Overview: Production error; immobilizer wire (orange/black) in pin position #4 instead of pin position #5. Although an effort to correct the issue was made, some quantity of harnesses did get shipped before the issue was spotted. We are advising to inspect the harness BLADE connector before attempting to install the harness and program the module.

Overview: The FTI-STP1 harness may require modification for use in **automatic transmission (AT)** applications, some of the product was able to be modified before release, but a small quantity was released before being able to be modified internally.

FTI-STP1: Installation and Configuration Notes

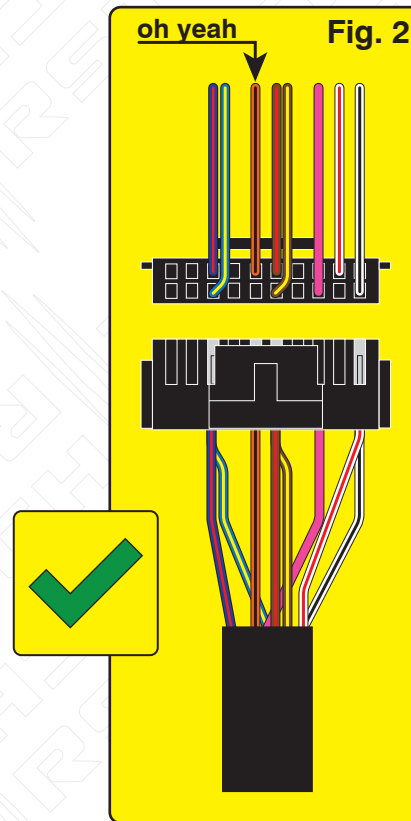
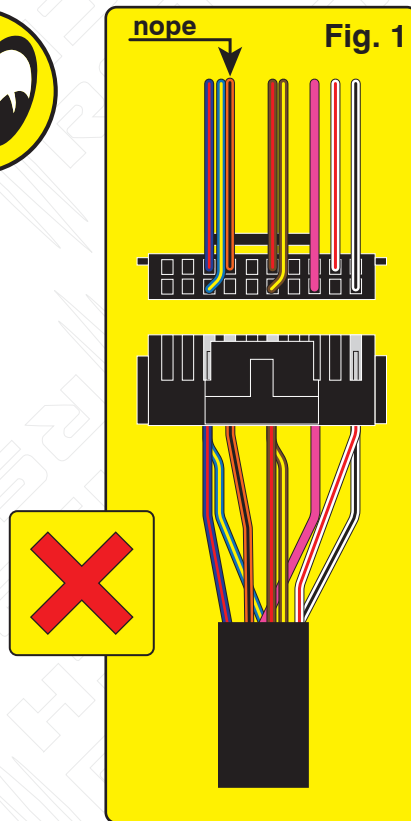
Issue: Module fails to program to vehicle, will not allow the vehicle to be remote started.

Correction: Step 1.) Locate the orange/black wire and confirm whether it is positioned as illustrated in Fig. 1 or Fig. 2. If the wire is as illustrated in Fig.1, proceed with Step 2 through 5 and complete the repair procedure outlined, if the wire is as illustrated in Fig. 2, correction is not necessary, proceed with harness installation and module programming.

Step 2.) Using a pick, lightly depress the catch that secures the terminal in the housing then remove the wire and terminal from the housing.

Step 3.) Using a fine tip razor or utility knife, insert the blade beneath the terminal catch and raise it slightly, so that it can be reused to secure the terminal when reinserted into the BLADE connector housing.

Step 4.) Refer to Fig. 2 for correct position of the orange/black wire (next to brown/red) then reinsert the terminal, pressing lightly until the catch 'snaps' into place, securing the terminal in the connector housing.

Step 5.) The repair is complete, proceed with installation and programming.

MODIFICATION REQUIRED FOR AUTOMATIC TRANSMISSION APPLICATIONS ONLY

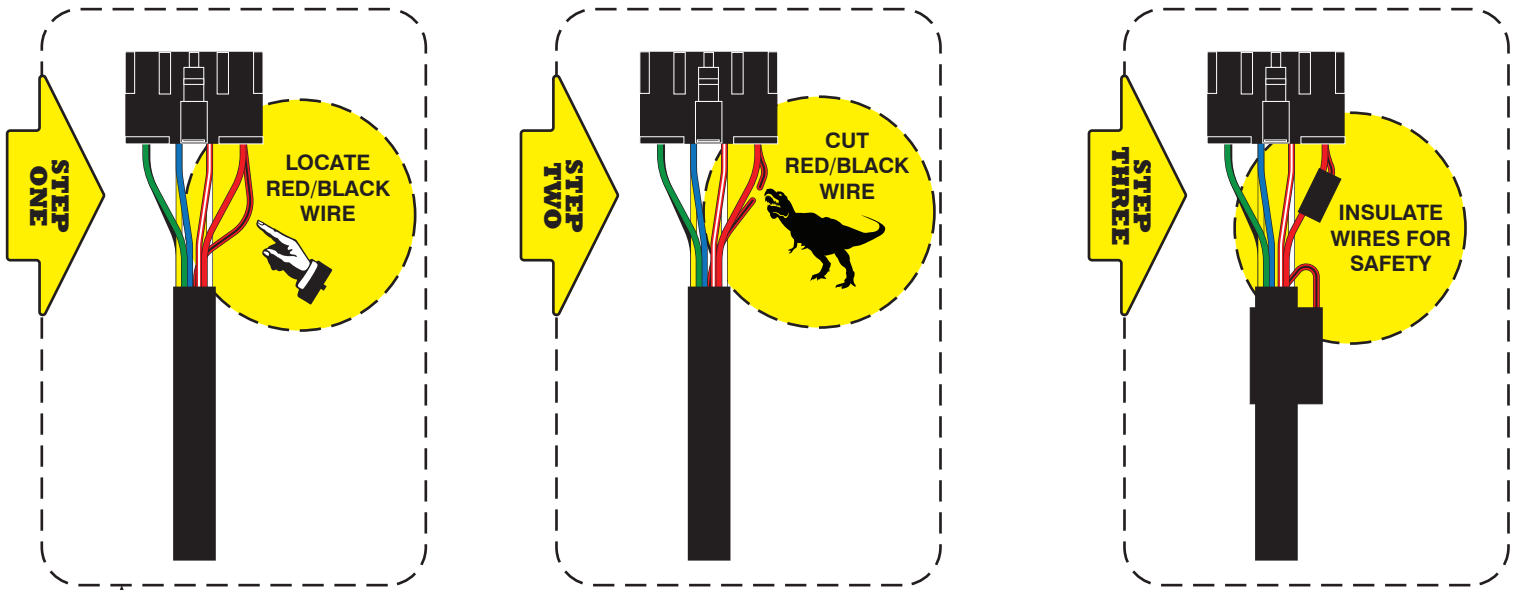
Issue: The FTI-STP1 T-harness has been designed to be compatible with AT (automatic transmission) & MT (manual transmission) applications, but due to a production oversight, the selection mechanism was defaulted to MT mode.

Using a harness configured for an MT application, in an AT equipped vehicle, could result in vehicle module damage, it is advised that the harness be returned to AT mode before installation in vehicles equipped with an automatic transmission.

Correction: Locate the **red/black (+ Clutch)** wire provided in the CN1 connector of the main harness assembly. Cut the **red/black** wire, either flush to the CN1 connector, or leaving enough wire exposed so that you can insulate and secure the ends of the wire that remain after cutting. Insulate each of the remaining ends of the **red/black** wire and secure to prevent any possibility of a short circuit.

If the red/black wire already been disconnected, no further modification is required for AT equipped vehicles.

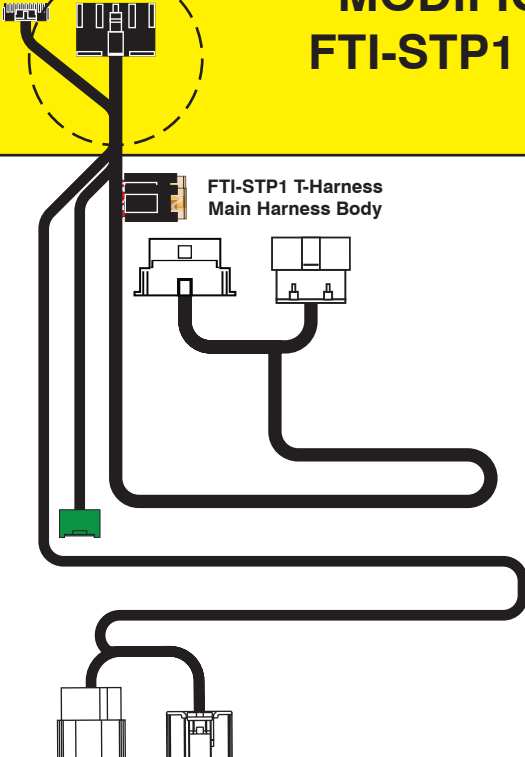
CMX, CM7, and CM9 Series controllers: No configuration changes required. See previous page for modification required at the CN1 connector parking light (+ clutch) output position.
